CIMARRON CORPORATION

Re: Docket No. 70-0295
License No. SNM-928
South Uranium Yard Decontamination
May 31, 1995 letter from Mr. Michael F. Weber to Mr. Jess Larsen

The purpose of this letter is to provide responses to the two issues identified in the above-referenced letter. The two issues were raised as a result of the April 24 and 25, 1995 ORISE confirmatory survey of the south uranium yard area located on the Cimarron site.

Figure 1

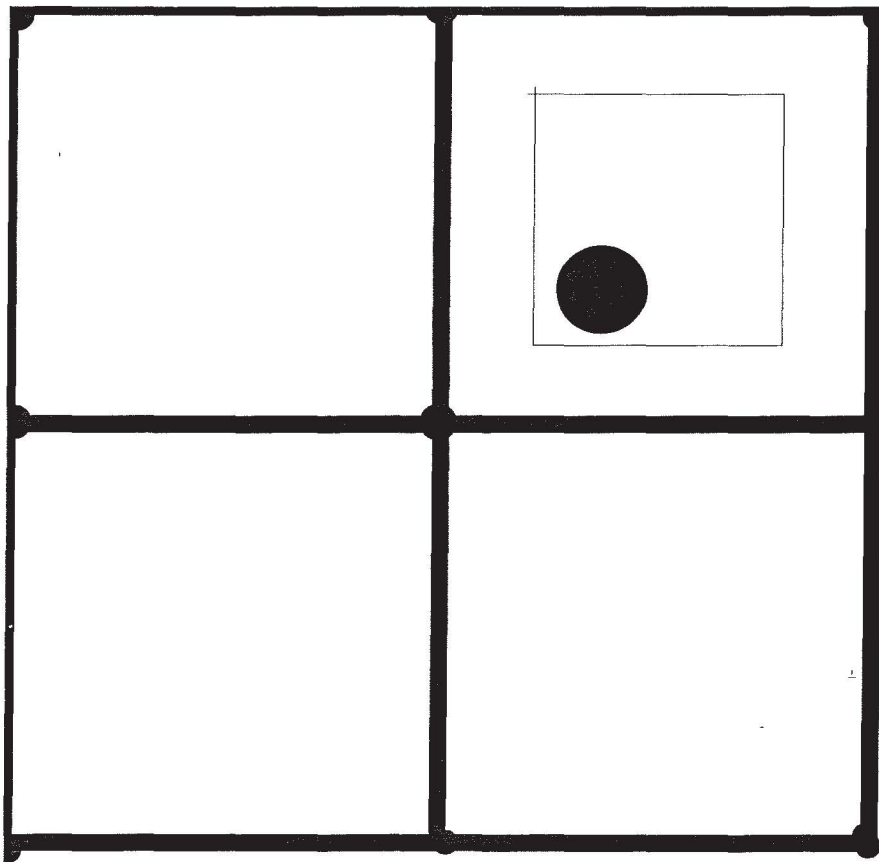
NRC Comment #1: First, the ORISE borehole sample from location #1 (see Enclosure 1), at the 0-15 cm depth, indicated a total uranium concentration of 38.4 pCi/g. Since 38.4 pCi/g exceeds the enriched uranium limit of 30 pCi/g, additional samples should be collected to determine compliance with the hot-spot limit using the procedure that was applied in the November 1994 "Report on the South Yard Remediation at the Cimarron Facility," (South Yard Report). NRC believes that it would be more efficient for Kerr-McGee to collect and analyze the additional samples as opposed to sending ORISE back to the Cimarron site to perform the work. The results of the additional samples should be submitted to NRC.

Response: Cimarron has performed additional gamma scans of the area surrounding the 38.4 pCi/g hot-spot identified by ORISE. These scans were performed using a 3" x 0.5" lead shielded sodium iodide detector. The surface gamma scan indicated that the area of the hot-spot was defined by a 3m x 3m boundary for a total of 9m². The 38.4 pCi/g hot-spot area and the 100m² area used to determine compliance with the NUREG/CR-5849 hot-spot averaging criteria are shown in Figure 1.

The 100m² area containing the 38.4 pCi/g hot-spot was evaluated based upon the criteria in NUREG/CR-5849. The hot-spot is less than three times the soil guideline value of 30 pCi/g total uranium. In addition, the calculation presented below shows that the average concentration is less than (100/A)^{1/2} times the guideline value of 30 pCi/g.

$$38.4 \text{ pCi/g} < (30) (100/A)^{1/2} = (30) (100/9)^{1/2} = 100 \text{ pCi/g}$$

The average activity in the 100m² contiguous area containing the hot-spot was also determined. NUREG/CR-5849 specifies that the average activity in the 100m² area must be less than or equal to the guideline value (≤ 30 pCi/g). This calculation is performed using the ORISE hot-spot data and the Cimarron characterization data.

$$\begin{aligned} \bar{x}_w &= 16.6 [1 - (9/100)] + 38.4 [9/100] = 18.6 \text{ pCi/g} \\ 18.6 \text{ pCi/g} &\leq 30 \text{ pCi/g} \end{aligned}$$

All criteria in NUREG/CR-5849 have been satisfactorily met. Therefore, the hot-spot identified by ORISE will not affect the conclusion that the South Uranium Yard meets all release criteria.

FIGURE 1

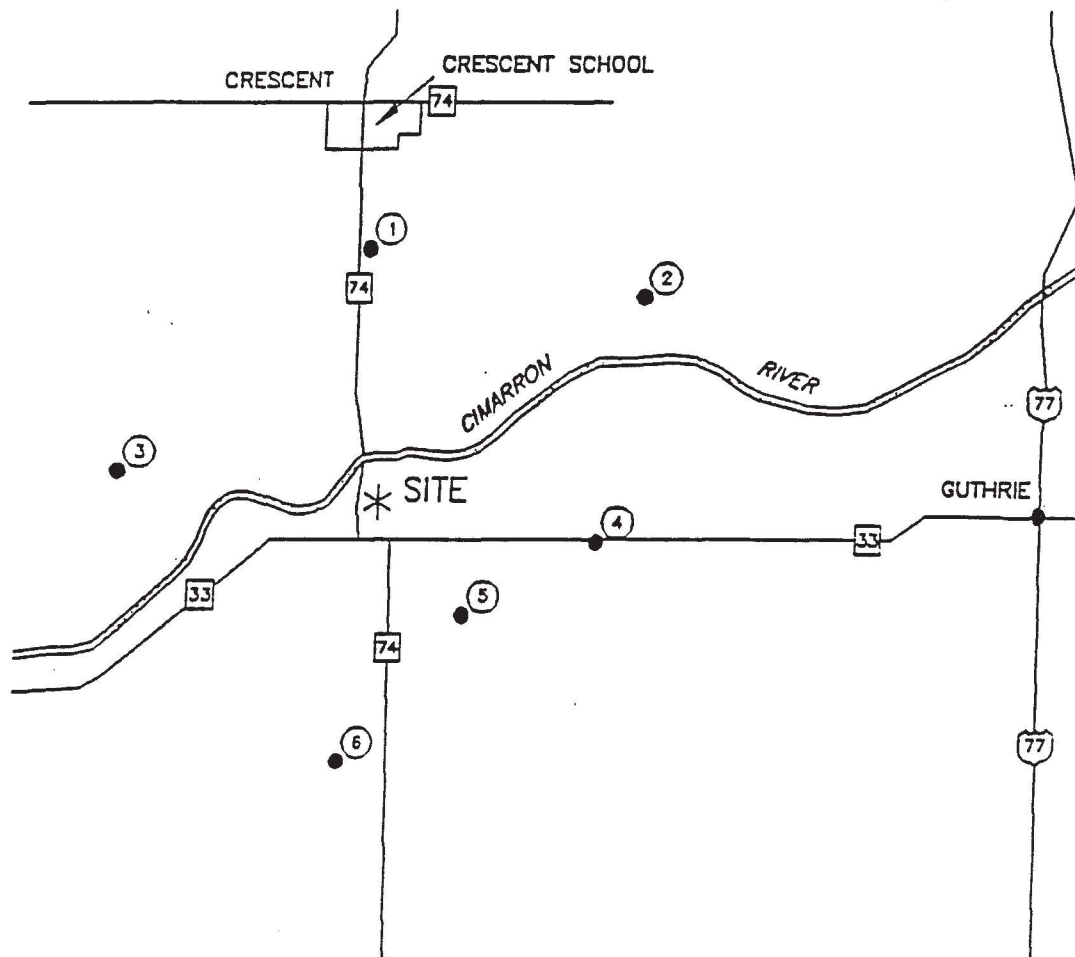
NRC Comment #2: Second, during the confirmatory survey, ORISE collected six samples from the vicinity of the Cimarron site to assess background uranium concentrations. The ORISE results for background concentrations of total uranium range from 0.80 to 1.86 pCi/g. These values differ from the background concentration of 6 pCi/g total uranium reported in the South Yard Report (page 4). Please provide an explanation for this apparent discrepancy.

ORAU prepared a report, "Confirmatory Radiological Survey Former Burial Ground Cimarron Corporation Facility Crescent, Oklahoma, July, 1992", which included analysis of six background soil samples collected near the Cimarron facility. The sampling locations are shown in Figure 1. Table 1 summarizes the total uranium data from the ORAU report. Total uranium in the six background soil samples ranged from less than 1.2 pCi/g to 2.0 pCi/g, based upon calculations performed using the gamma spectroscopy data. The average concentration for the samples, assuming that the actual concentration for the two reported "less than" values are equal to the maximum possible values, was reported as 1.6 pCi/g.
